ADDENDUM – No. 1

PROJECT	GRIZZLY GULCH PLACER MINE RECLAMATION PROJECT
BID DATE	BY 4:00 PM ON 12/16/2024
BID LOCATION	Office of the Board of County Commissioners, Room 345, City-County Building, 316 N. Park Avenue, Helena, MT 59623
ISSUE DATE	12/6/2024
NOTICE	Failure to acknowledge all addenda in the BID may cause rejection of the BID. See updated Bid Proposal Worksheet.

SCOPE OF THIS ADDENDUM

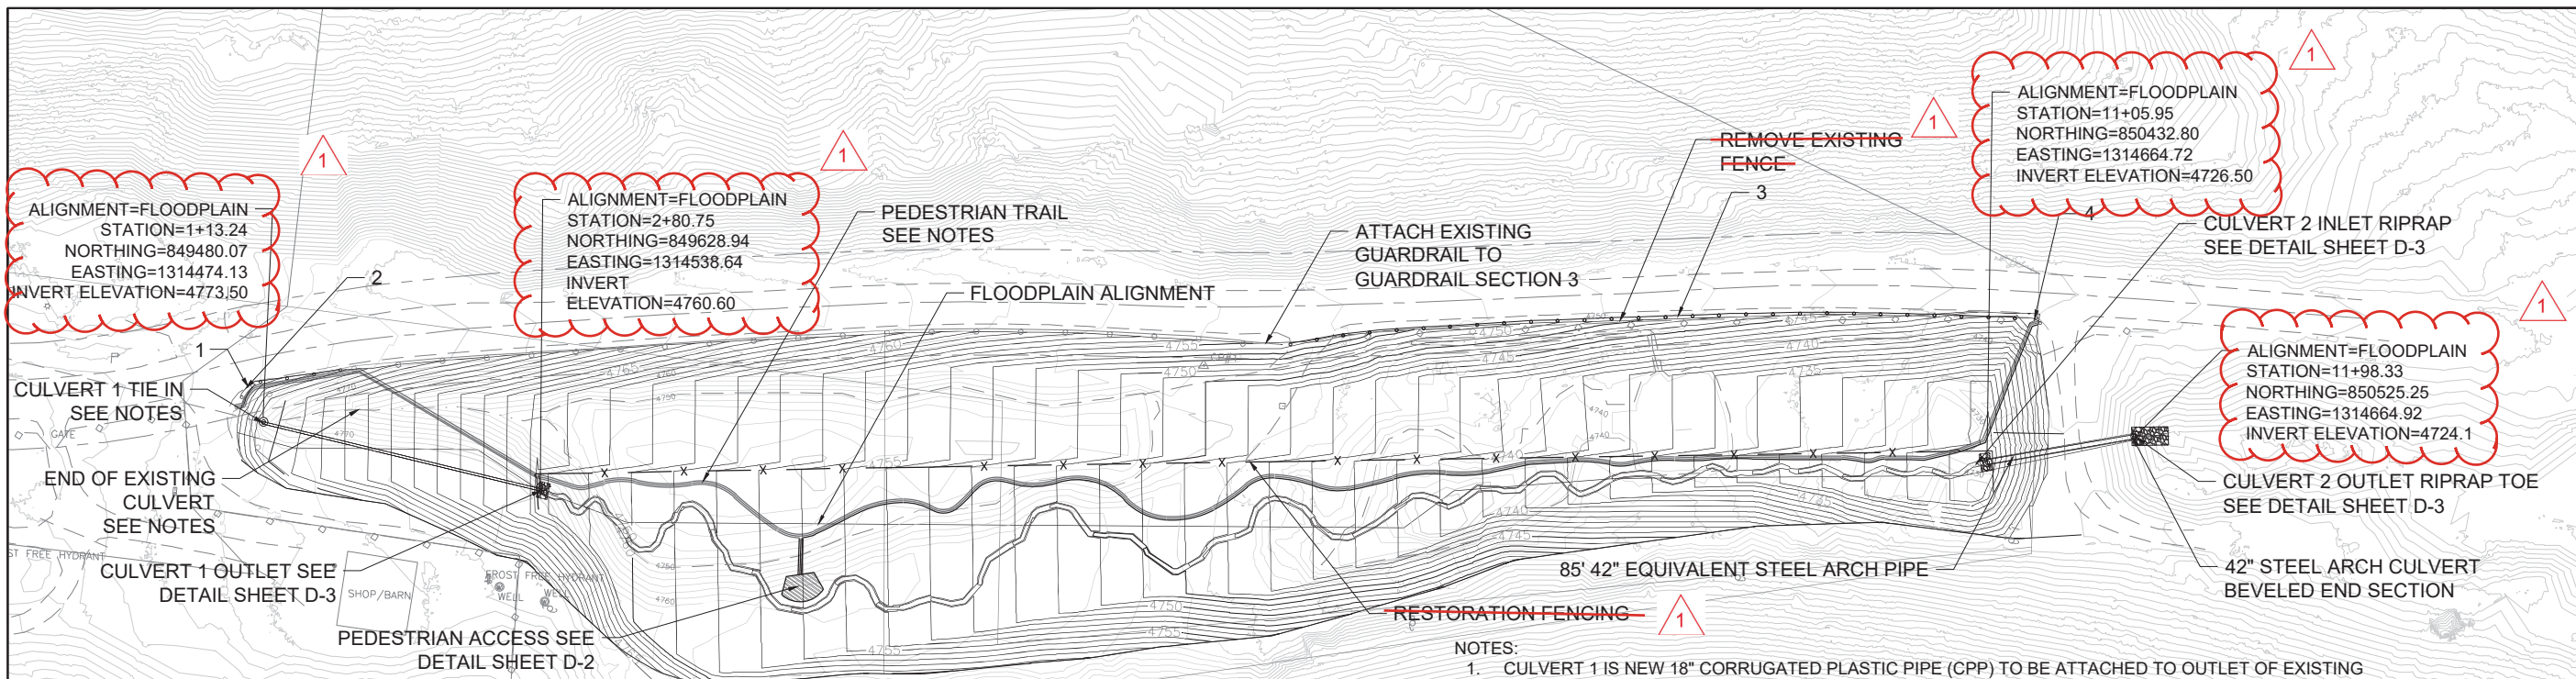
Replace: Sheet G-2 with Sheet G-2R

This sheet has been replaced with the attached Sheet G-2R to clarify unclassified excavation quantity, add an additional excavation quantity associated with the CPP culvert placement, and to remove the "remove existing fence" quantity as this activity will be handled by the Landowner.

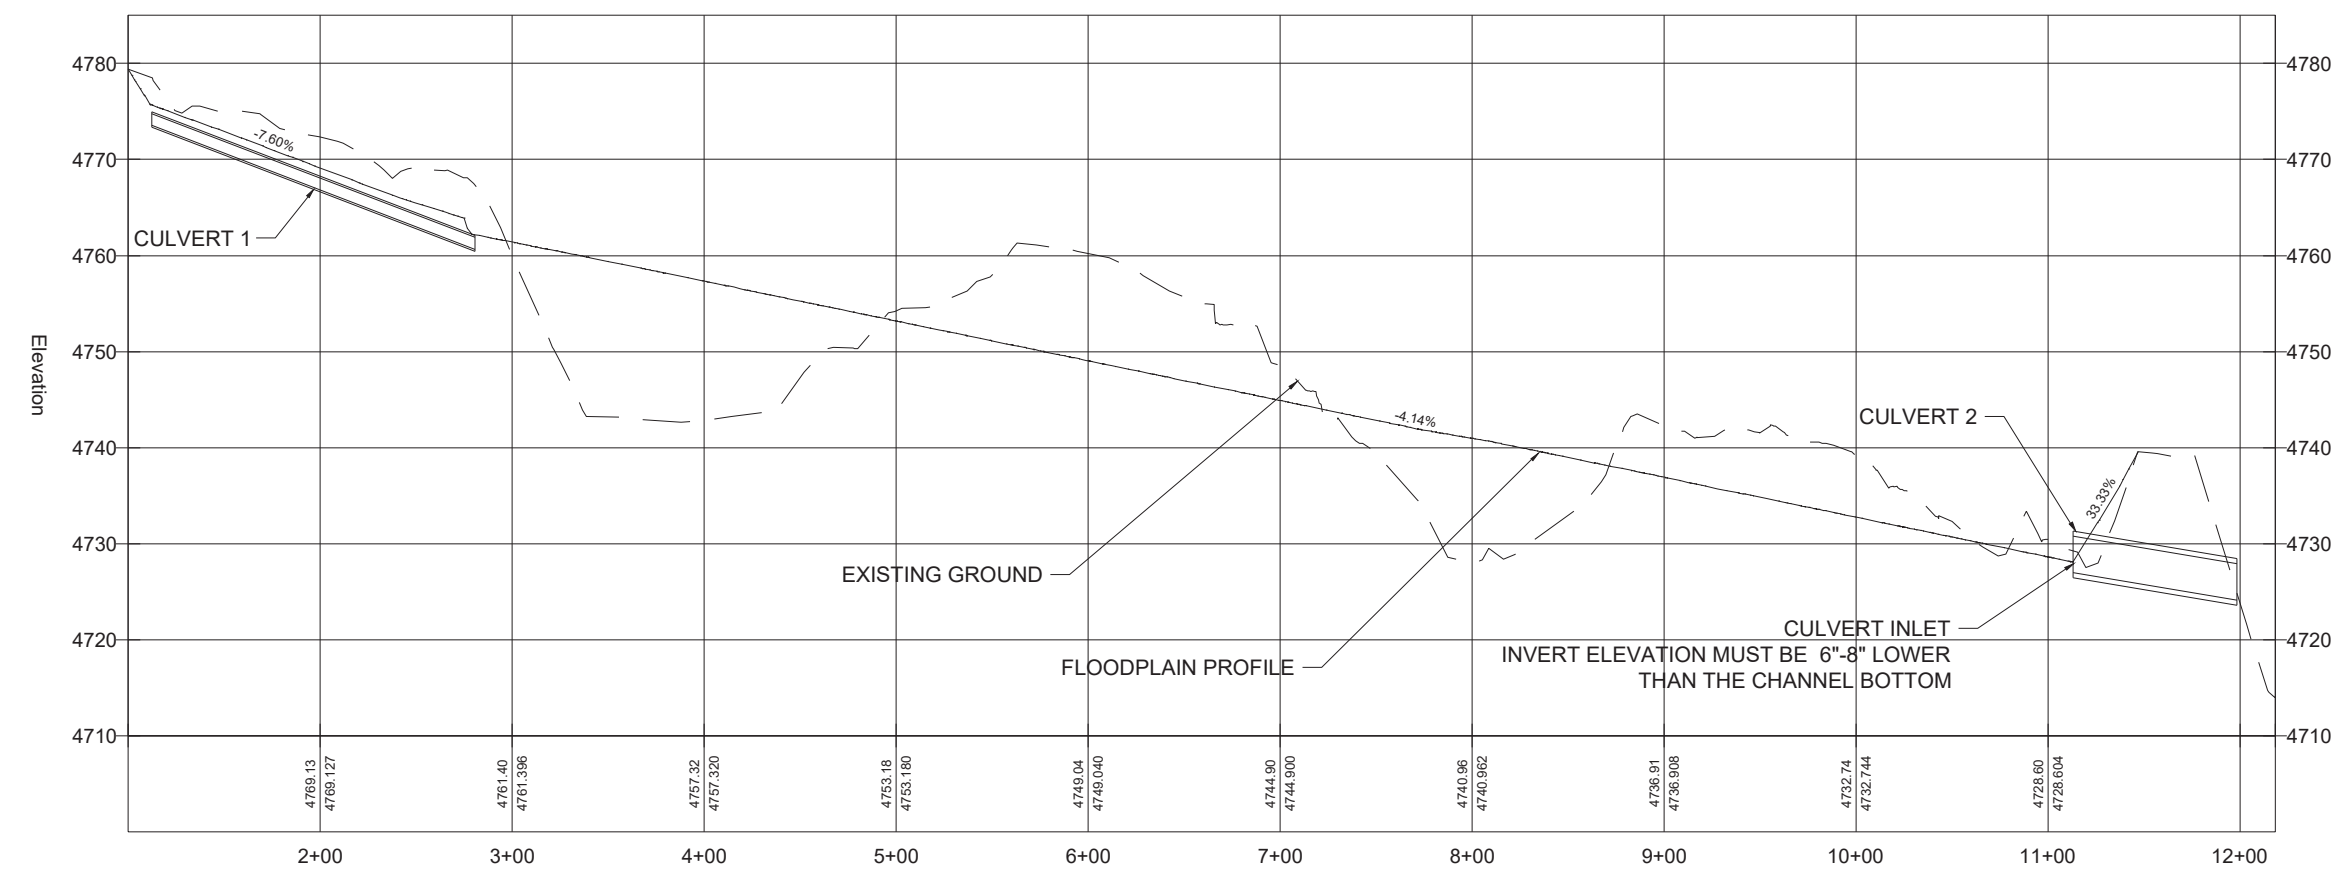
Replace: Sheet C-2 with Sheet C-2R

This sheet has been replaced with the attached Sheet C-2R to remove the indication that restoration fence installation and existing fence removal is required for the project. Stationing and elevations of culvert inverts were added to provide additional information about placement.

SHEET NUMBER:
C-9R

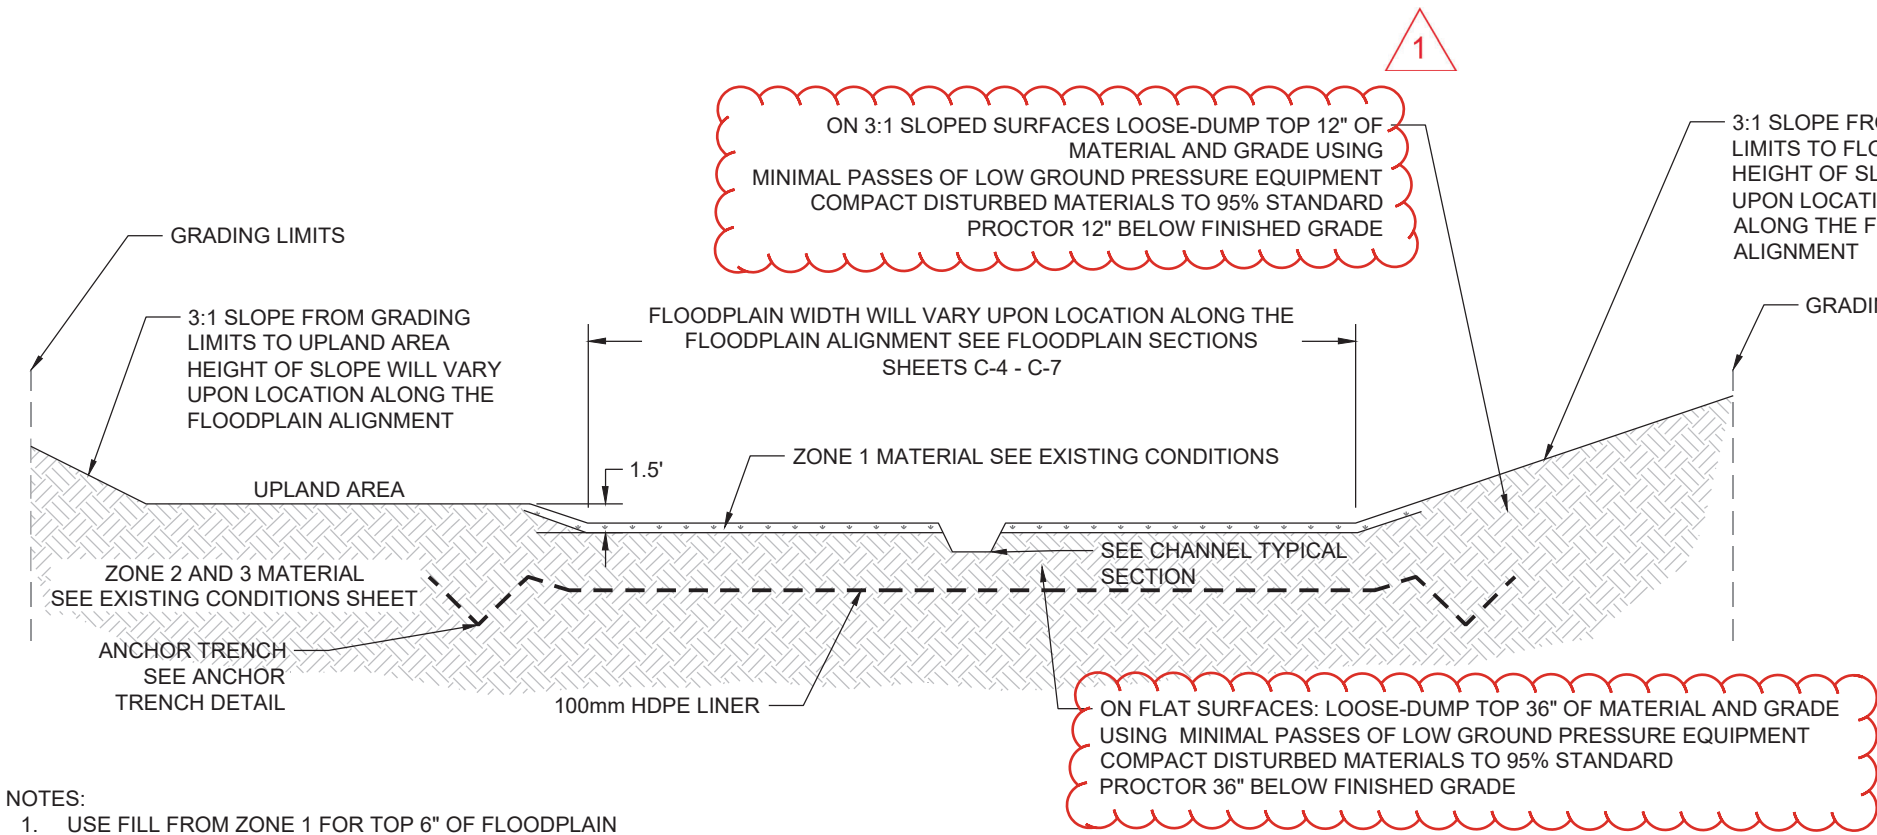
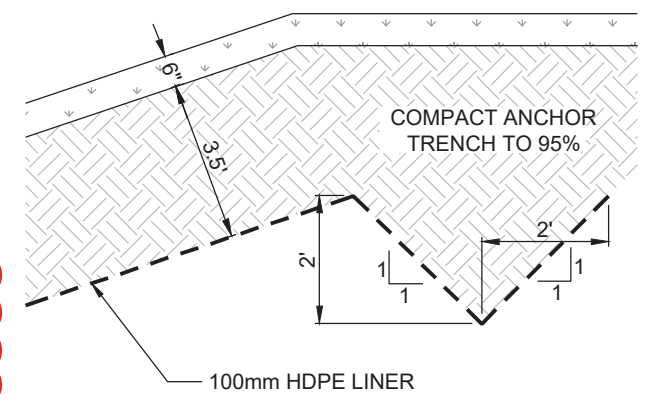
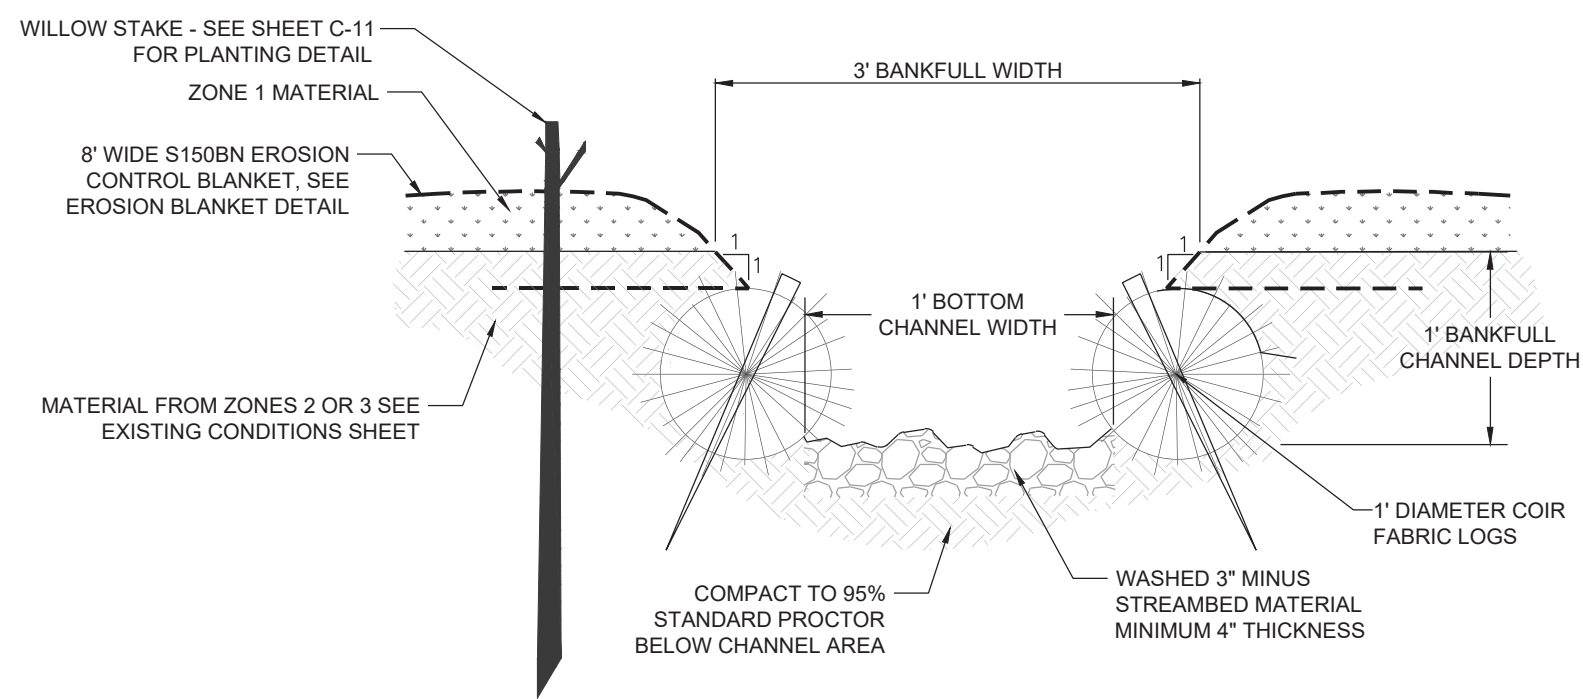
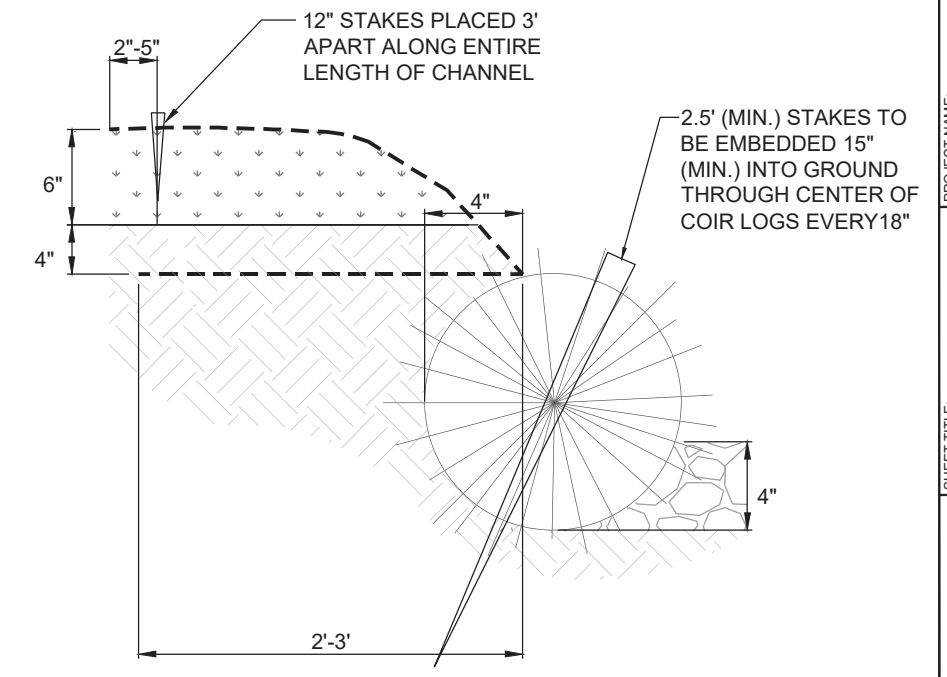
Replace: Sheet C-9 with Sheet C-9R

This sheet has been replaced with the attached Sheet C-2R to reflect updated compaction and material placement methods for 3:1 slopes and flat surfaces.

- NOTES:
 1. USE FILL FROM ZONE 1 FOR TOP 6" OF FLOODPLAIN
 2. FILL IN UPLAND AREA AND ON 3:1 SLOPES CAN BE SOURCED FROM EITHER ZONES 2 OR 3
